Executive Director's Recommendation

Commission Meeting: October 3, 2024

PROJECT Fallen Journalists Memorial 300 Independence Avenue, SW Washington, DC	NCPC FILE NUMBER 8449
SUBMITTED BY United States Department of the Interior, National Park Service	NCPC MAP FILE NUMBER 1.71(73.10)45887
REVIEW AUTHORITY Commemorative Works per 40 U.S.C. § 8905	APPLICANT'S REQUEST Approval of comments on concept plans
	PROPOSED ACTION Approve comments on concept plans
	ACTION ITEM TYPE Staff Presentation

Approval of Comments on Concept Plans

Grove of Trees

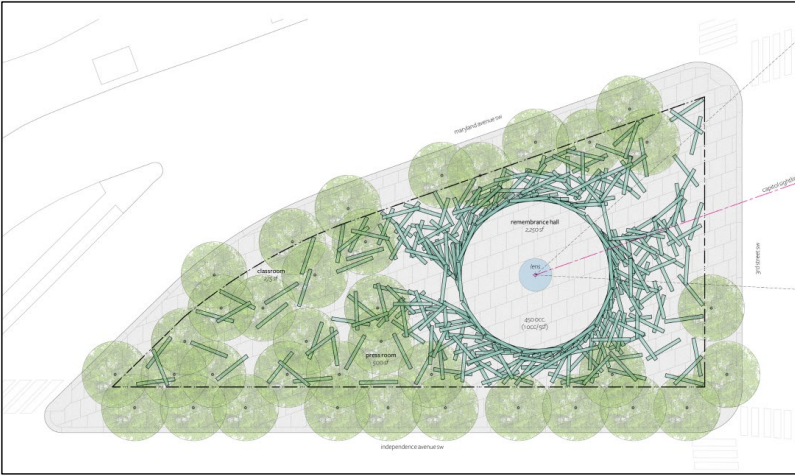
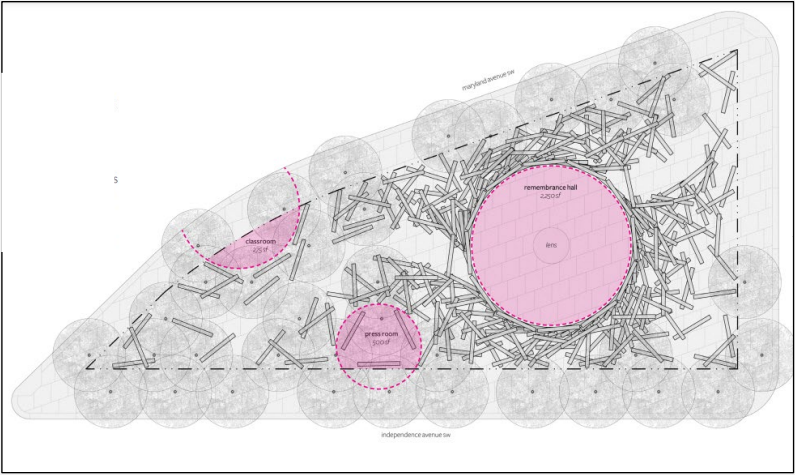
Finds that while the concept design includes a grove of trees, the site is proposed to be fully paved, which in combination with the glass elements, may impact visitor comfort particularly during the warmer months of the year.

Requests the applicant evaluate additional approaches to enhancing visitor comfort and reducing the urban heat island effect, including alternative ground treatments and tree wells, and additional trees and alternate species, and other landscaping.

In general, the memorial design should consider visitor comfort. The proposed design includes a grove of honey locust trees, but no other plantings or other strategies to help reduce heat on-site. Staff recommends the **Commission find that while the concept design includes a grove of trees, the site is proposed to be fully paved, which in combination with the glass elements, may impact visitor comfort particularly during the warmer months of the year.** Additional approaches could be considered as the design develops, including additional plantings, trees species with broader canopies, or reduced paving. Therefore, staff suggests the **Commission requests the applicant evaluate additional approaches to enhancing visitor comfort and reducing the urban heat island effect, including alternative ground treatments and tree wells, and additional trees and alternate species, and other landscaping.**

ADA and ABA Requirements

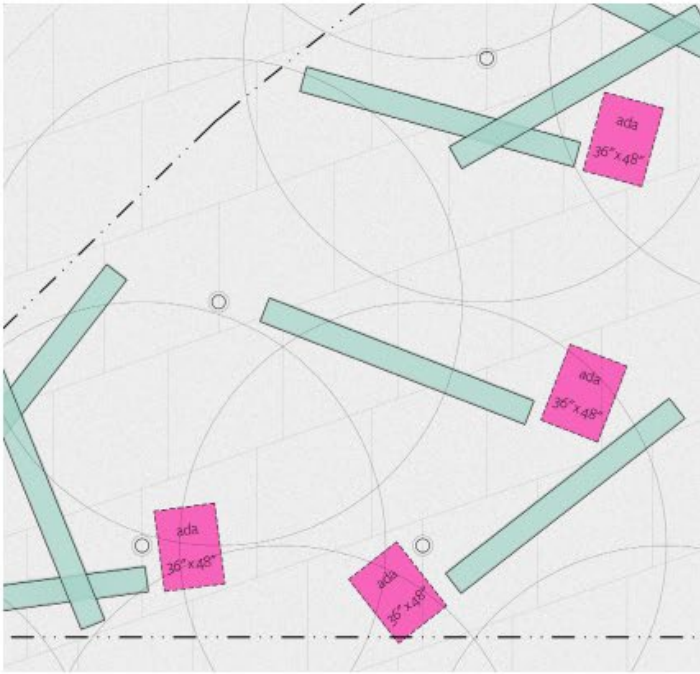
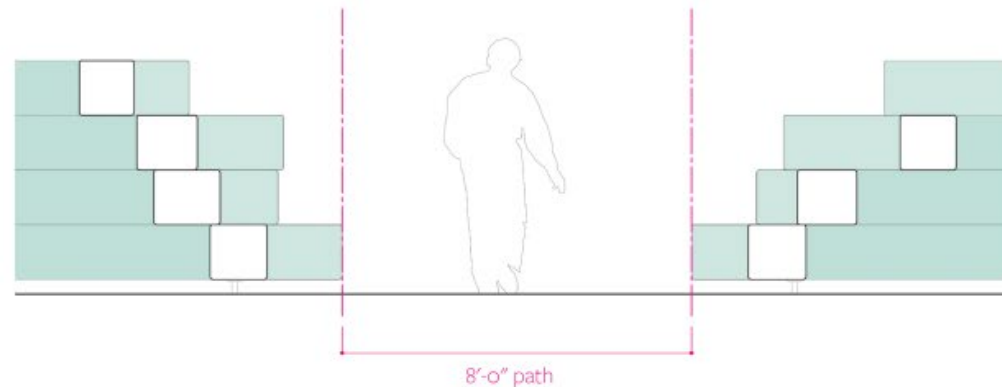
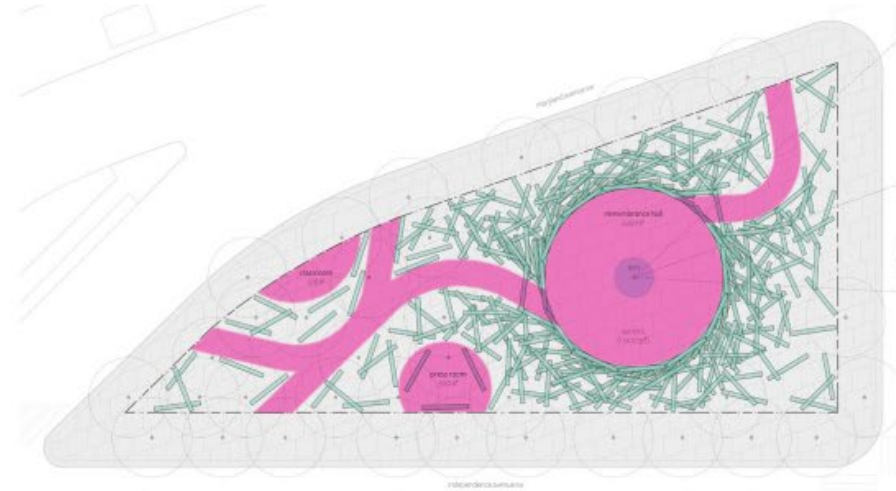
Finds circulation and access for visitors, particularly from the perimeter of the site, may be challenging to perceive or navigate, especially for those with mobility concerns or visual impairments.

Recommends the applicant continue to refine the access and circulation, with a focus on creating clear paths of movement that will help guide visitors of all abilities through the memorial.

Capitol View Study

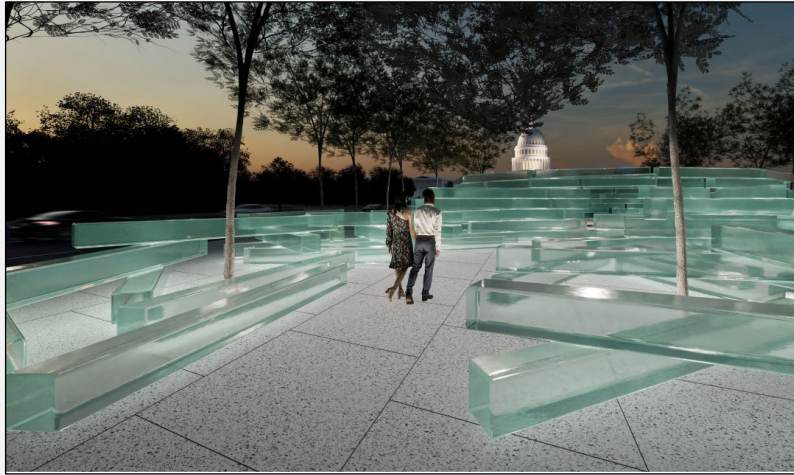
Notes the central Remembrance Hall is intended to provide a view toward the U.S. Capitol dome.

Requests the applicant continue to explore the overall height and design of the Remembrance Hall to better frame the view to the U.S. Capitol Dome.

Regarding internal views, staff notes the central Remembrance Hall is intended to provide a view toward the U.S. Capitol dome. The submission indicates the applicant is exploring the appropriate height of the glass blocks to help preserve the view from the Hall to the Dome. A lower height may be appropriate to help protect the view, but further exploration is needed. As such, staff recommends the **Commission requests the applicant continue to explore the overall height and design of the Remembrance Hall to better frame the view to the U.S. Capitol Dome.**
